Marion St Bridge

**Office of Planning and
Community Development
Seattle City Hall**
600 4th Avenue, 5th Floor
Seattle, WA 98124

This was the Seattle Design Commissions (SDC) second review of the Marion Street Bridge project. The purpose of this meeting was to review the schematic design (60% design phase) for the project. After the presentation and discussion, the SDC voted 6 to 0 to approve the schematic design, with several recommendations.

Schematic Design (60% Phase)

Figure 3: Bridge lighting - Option C

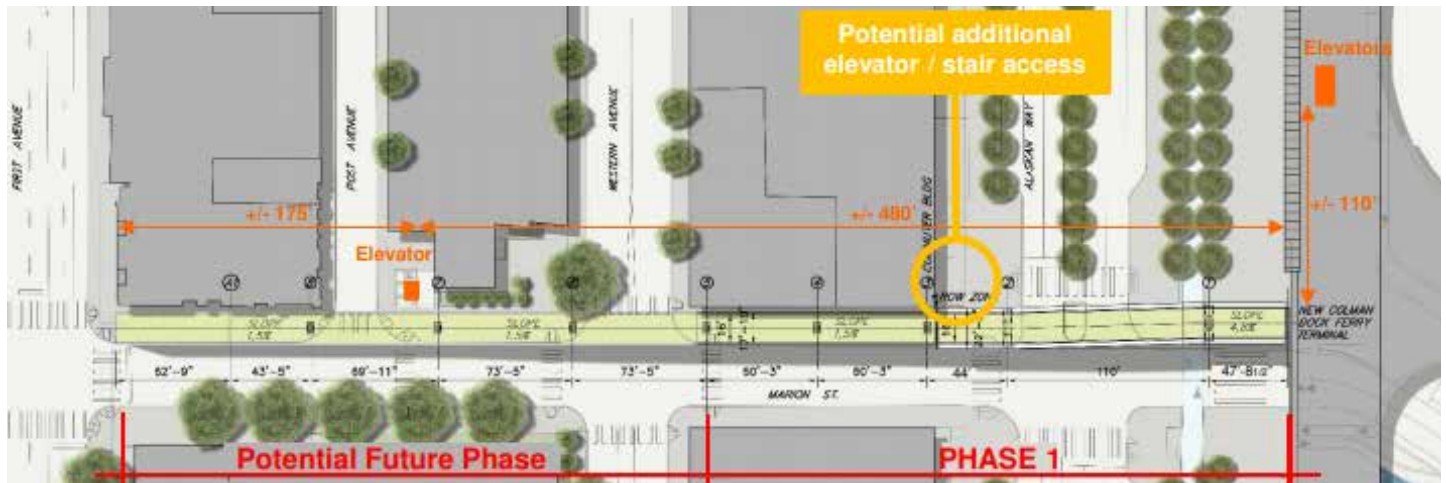
The SDC appreciated the project team providing alternative lighting schemes. The commission preferred Option C lighting scheme. Commissioners agreed this option would provide the necessary amount of lighting while supporting the overall bridge design.

1. Recommend Option C lighting scheme
2. Continue to discuss the possibility of integrating vertical circulation within the adjacent development. Ensure the potential connection is as public as possible.
3. Study how to protect pedestrians from potential conflicts with the columns with a lower V structure.
